2015/06/26

MVSY-156-1A&2A Mounting Position Change Notification

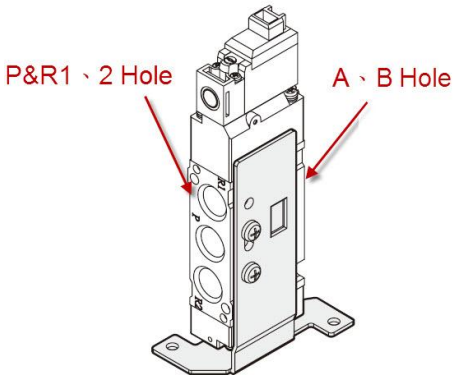
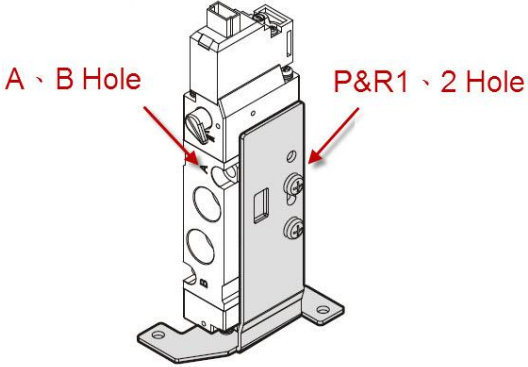
3. Design change

A. **MVSY-156-1A** bracket mounting position:

B. **MVSY-156-2A** bracket mounting position:

Before	After

To unify the mounting position of bracket on MVSY series.
